Chittaranjan Locomotive Works
Chittaranjan, West Bengal

Name	Arka Dey
Department	Project Management
Telephone	+91 124 624 6448
Fax	
Mobile	+91 9051040047
E-Mail	arka.dey@siemens.com
Your letter of	
Our reference	SMO/RS/Propulsion/Software Trial
Date	14.04.2025

Sub: Request for trial of software before regular approval**Ref:**

Annexure B – proposed integration in electrical schematic

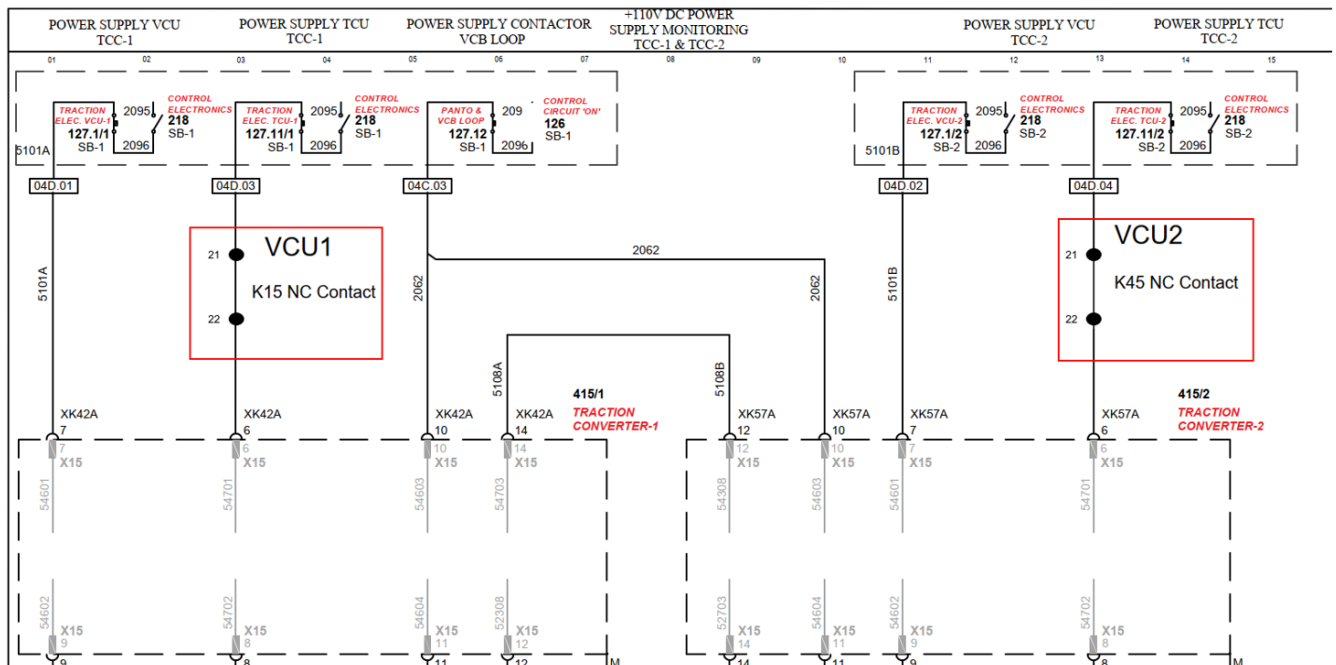
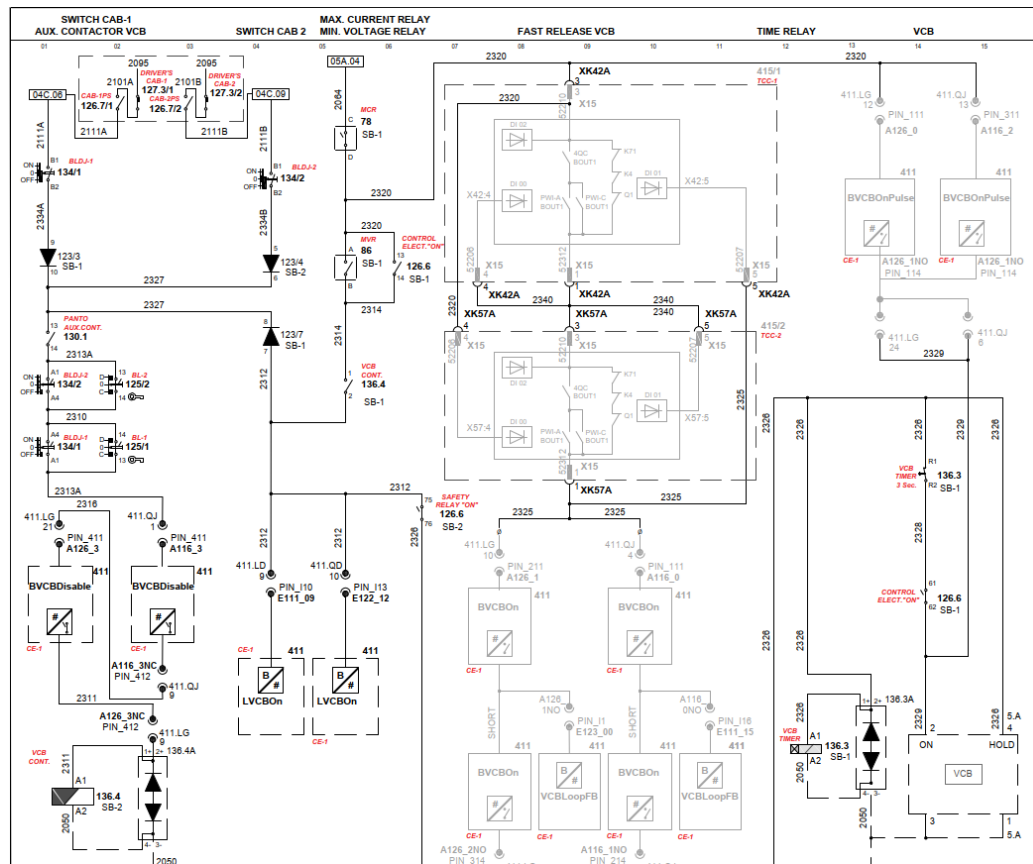
Hence, the proposed solution is to switch off 110V power supply for TCC (TCU off, bypass set, Q1 safe in open position)

We propose to add **one Contactor Relay** (rated for 110 VDC control supply) inside each VCU cubicle, as follows:

- 1) **Control Voltage Source:** Drawn from SB panel to maintain independence from VCU systems.
- 2) **Control Method:** Remotely operated via CCU.
- 3) **Location:** Mounted inside existing provision in VCU-1 and VCU-2.
- 4) **Relay Type:** Siemens 3RH2131-2XF40-0LA2 (Datasheet in Annexure A).

Annexure C

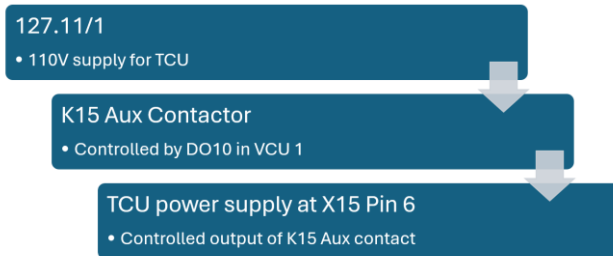
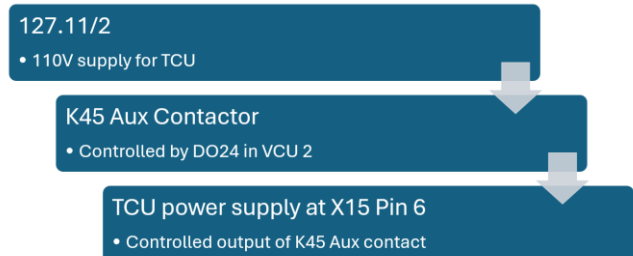
Cabling scheme of K71 for TC-1

Cabling scheme of K71 for TC-2

VCU 1	VCU 2
DO 10 (NO)	DO 24 (NO)
Aux Contact K15 A1+ (NO) Aux Contact K15 A2- (TBN)	Aux Contact K45 A1+ (NO) Aux Contact K45 A2- (TBN)
Cable 0.5sqmm

VCU 1 K15	VCU 2 K45
Aux Contact 21NC (CB Power supply gate unit) (2601A)	Aux Contact 21NC (CB Power supply gate unit) (2601B)
Aux Contact 22NC (XK22R 6 SB1)	Aux Contact 22NC (XK77R 6 SB2)
